# Access Compliance Report

## Public Rights-of-Way

### (Curb Ramps)

Intersection ID: 12877	Main Street: E_5TH_ST	Cross Street: N_MYERS_ST	Location: W
ADA ID: D8C893A57783	Ramp Type: PerpDiag	Initial Pass/Fail: Fail	Overall Compliance: No
Severity Score: 12.5			
Codes/Mitigation Info/Possible Solution		Field Measurements/Component Compliance

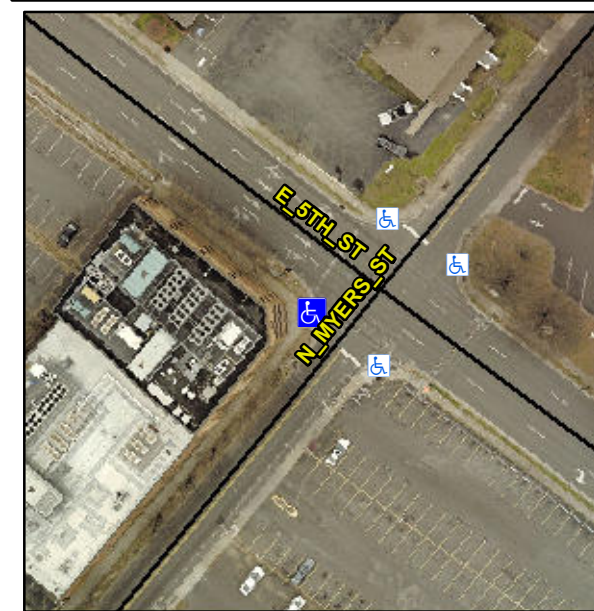
**Not Found, R304.5.3**

Compliance	Description	Data	Compliance	Description	Data
N/A	Ramp Length (in)	63.0	Yes	Ramp Slope (%)	6.1
Yes	Ramp Width (in)	48.0	No	Ramp XSlope (%)	6.7
N/A	Flare Type LT	N/A	N/A	Flare Type RT	N/A
N/A	Flare Slope LT (%)	N/A	N/A	Flare Slope RT (%)	N/A
N/A	Flare Traversable LT?	N/A	N/A	Flare Traversable RT?	N/A
N/A	Landing Length (in)	N/A	N/A	DWS Provided?	N/A
N/A	Landing Width (in)	N/A	N/A	DWS Contrast?	N/A
N/A	Landing Slope (%)	N/A	N/A	DWS Length (in)	N/A
N/A	Landing X Slope (%)	N/A	N/A	DWS Full Width?	N/A
N/A	Landing Curb? (Y/N)	N/A	N/A	DWS Offset (in)	N/A
N/A	Shared Landing?	N/A			
N/A	Gutter Ponding?	N/A	N/A	Gutter Slope (%)	N/A
N/A	Gutter Lip Ht (in)	N/A	N/A	Gutter X Slope (%)	N/A
N/A	Painted X Walk1?	No	N/A	Painted X Walk2?	No
	X Walk 1 Direction	To SE		X Walk 2 Direction	To NE
N/A	X Walk 1 Width (in)	N/A	N/A	X Walk 2 Width (in)	N/A
	X Walk 1 Slope (%)	0.2		X Walk 2 Slope (%)	3.0
	X Walk 1 X Slope (%)	1.1		X Walk 2 X Slope (%)	4.0

**Remove & Replace Curb Ramp With Two New Directional Ramps or Equivalent.**
